Access Compliance Report

Public Rights-of-Way

(Curb Ramps)

Intersection ID: 12144	Main Street: ALLEGHANY_ST	Cross Street: WILKINSON_BV	Location: NE
ADA ID: 9714D5401CDC	Ramp Type: Perp	Initial Pass/Fail: Fail	Overall Compliance: No
Severity Score: 22.5			
Codes/Mitigation Info/Possible Solution		Field Measurements/Component Compliance

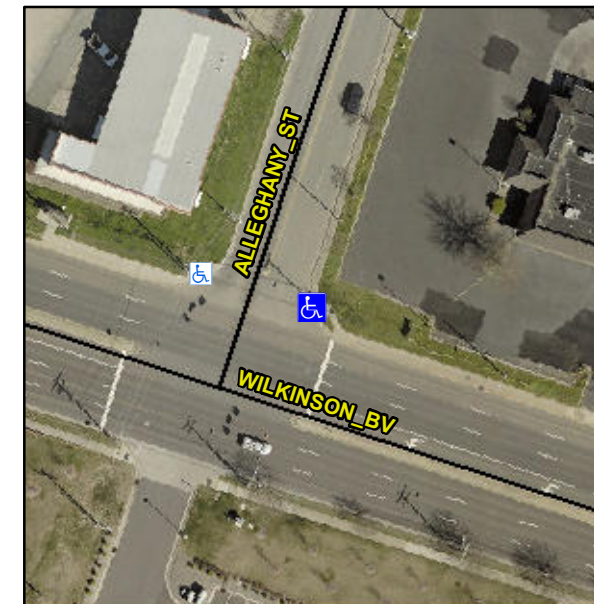
Not Found, R304.5.1, R304.2.2, R304.5.3

Compliance	Description	Data	Compliance	Description	Data
N/A	Ramp Length (in)	73.5	No	Ramp Slope (%)	10.0
No	Ramp Width (in)	47.0	No	Ramp XSlope (%)	4.9
N/A	Flare Type LT	N/A	N/A	Flare Type RT	N/A
N/A	Flare Slope LT (%)	N/A	N/A	Flare Slope RT (%)	N/A
N/A	Flare Traversable LT?	N/A	N/A	Flare Traversable RT?	N/A
N/A	Landing Length (in)	N/A	N/A	DWS Provided?	N/A
N/A	Landing Width (in)	N/A	N/A	DWS Contrast?	N/A
N/A	Landing Slope (%)	N/A	N/A	DWS Length (in)	N/A
N/A	Landing X Slope (%)	N/A	N/A	DWS Full Width?	N/A
N/A	Landing Curb? (Y/N)	N/A	N/A	DWS Offset (in)	N/A
N/A	Shared Landing?	N/A			
N/A	Gutter Ponding?	N/A	N/A	Gutter Slope (%)	N/A
N/A	Gutter Lip Ht (in)	N/A	N/A	Gutter X Slope (%)	N/A
N/A	Painted X Walk1?	No	N/A	Painted X Walk2?	N/A
	X Walk 1 Direction	To NW		X Walk 2 Direction	N/A
N/A	X Walk 1 Width (in)	N/A	N/A	X Walk 2 Width (in)	N/A
	X Walk 1 Slope (%)	2.5		X Walk 2 Slope (%)	N/A
	X Walk 1 X Slope (%)	9.4		X Walk 2 X Slope (%)	N/A

Remove & Replace Entire Ramp.
